Re: Notice of *Ex Parte* Presentation, GN Docket No. 23-135; ICFS File No. SAT-MOD-20230207-00021

Omnispace Response to SpaceX *Ex Parte* of 26 July 2023

GN Docket No. 23-135

ICFS File No. Sat-MOD-20230207-00021

Overlay of field of view with 7,500 satellite SpaceX constellation

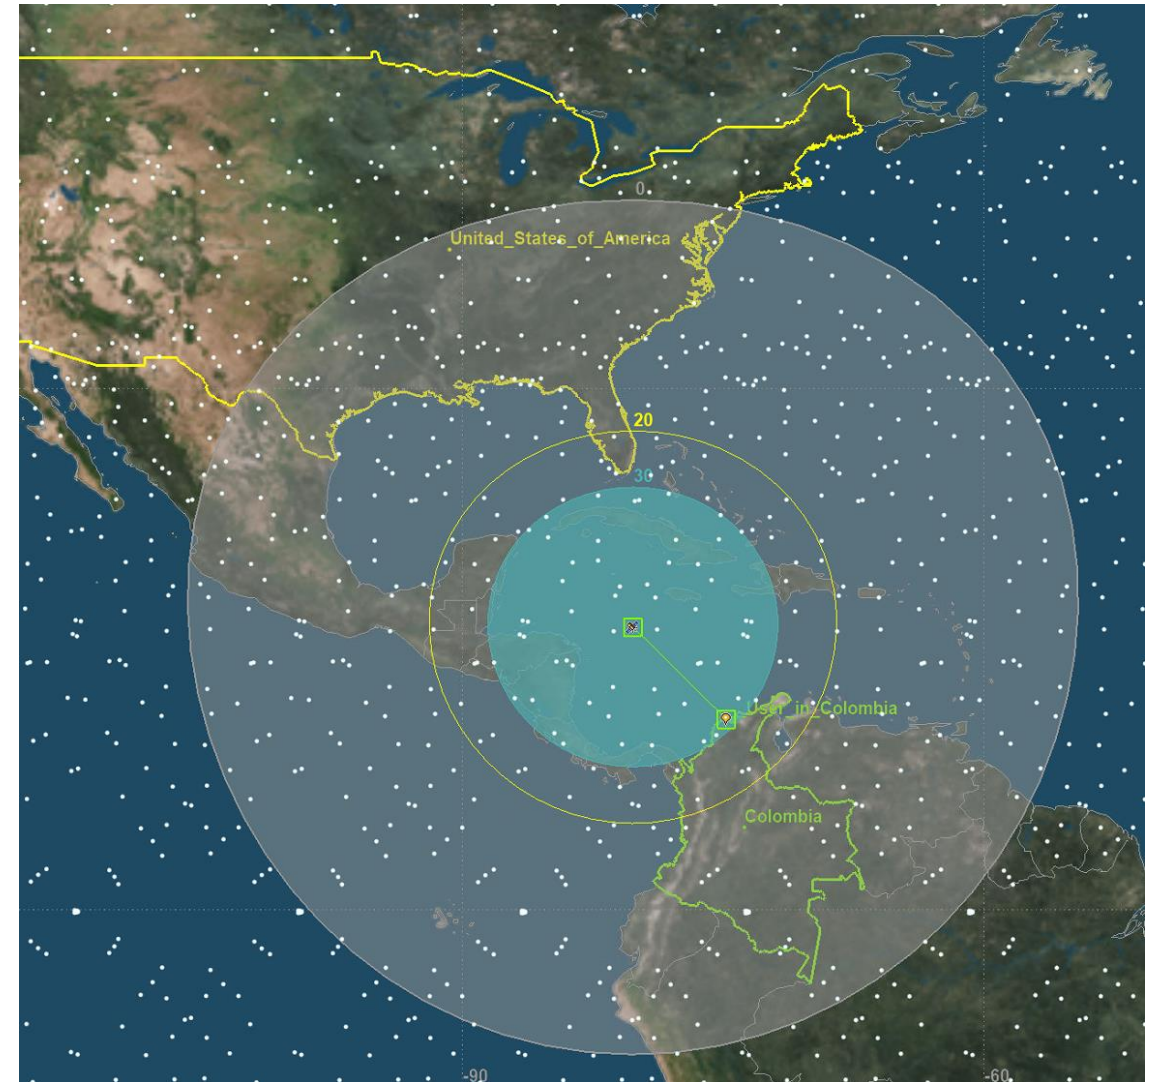
- SpaceX considers only the impact of a single satellite
- Omnispace showed that there would be on the order of 100 SpaceX satellites serving the US in view of a single Omnispace satellite serving Colombia
 - SpaceX noted it should be 188 not 100 satellites so this graphic vastly undercounts the SpaceX planned system
- SpaceX's latest calculations consider the aggregate power of the interfering signals from the 180 satellites in view of a single Omnispace satellite serving nearby Colombia, but incorrectly set the thermal noise level and significantly underestimate the interference
- Source: Page 11, Omnispace *Reply Comments To Responses*, 5 June 2023

SpaceX representation of noise floor is incorrect by 11.4 dB

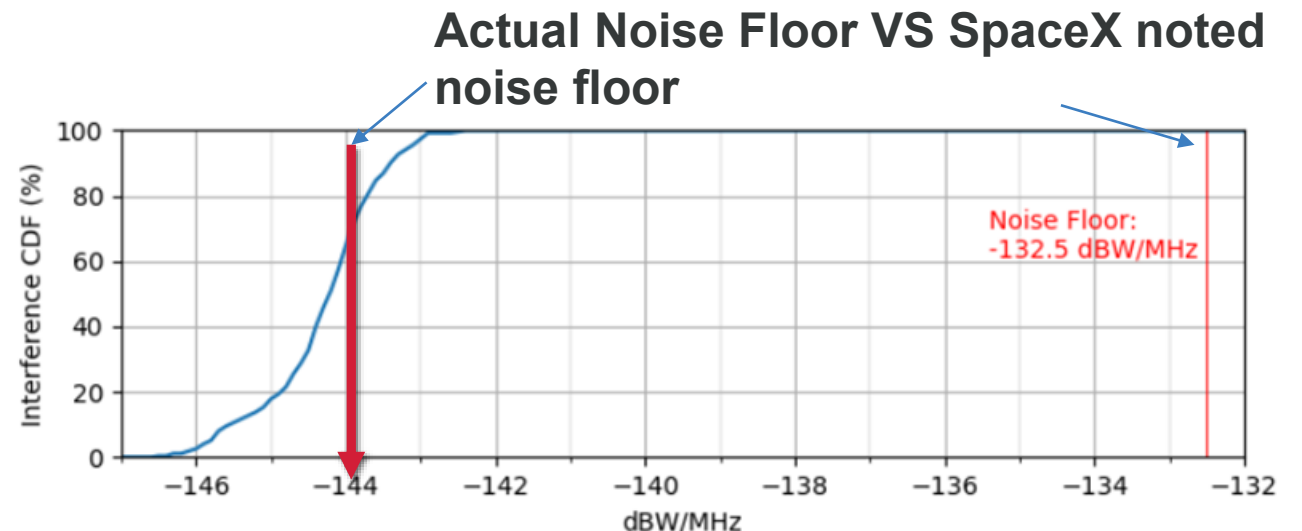
- Using SpaceX's own claimed antenna performance, SpaceX then declares that no interference is generated, however, there is a **significant error** in its interference analysis as SpaceX uses an **incorrect** thermal noise floor of **-132.5 dBW/MHz**

- Thermal noise in one MHz is an established fact, yet SpaceX misrepresents this in its analysis
- The total thermal noise power $N = (kTB)$ is a function of three entities:
 - Boltzmann's constant "k" in Joules/°K
 - Temperature T in degrees °Kelvin
 - Bandwidth of the channel B in Hz.

Noise power $N = 10 \times \log_{10}(k \times T \times B)$ in dBW/Hz

For B = 1 MHz $N = 10 \times \log_{10}(1.38 \times 10^{-23} \times 290^\circ \times 1,000,000) = -144$ dBW/MHz

- SpaceX claims this level is -132.5 dBW/MHz

- Using SpaceX's own questionable antenna performance numbers, and by its own admission, SpaceX interference will be equal to or greater than the noise floor based upon the real noise floor and number of satellites in view
